Trilennium[®] Mortise Lock

Old vs. New Styles

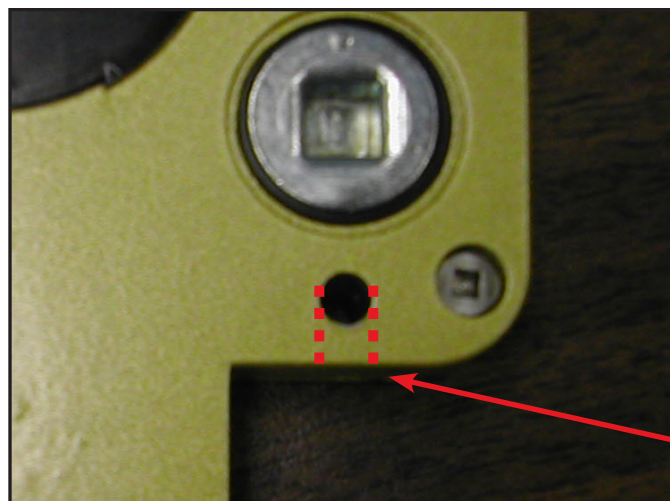
If you are replacing your Trilennium handset and encounter difficulties with installation, it could be due to a mismatch between the mortise lock design and the handset. If you have an older lock (prior to 2005), the location for the mounting screw is a **hole**, compared with the **slot** in the newer designs (post 2005).

Round Mounting
Screw Hole

Slot for
Mounting
Screw

To make your old mortise lock compatible with the new handsets, you will need to remove the lock from the door panel to modify it. Once it is removed, cut up vertically from the edge of the lock to meet the screw hole, as shown in the image below.

Cut up vertically from the
edge of the lock to meet
the screw hole.
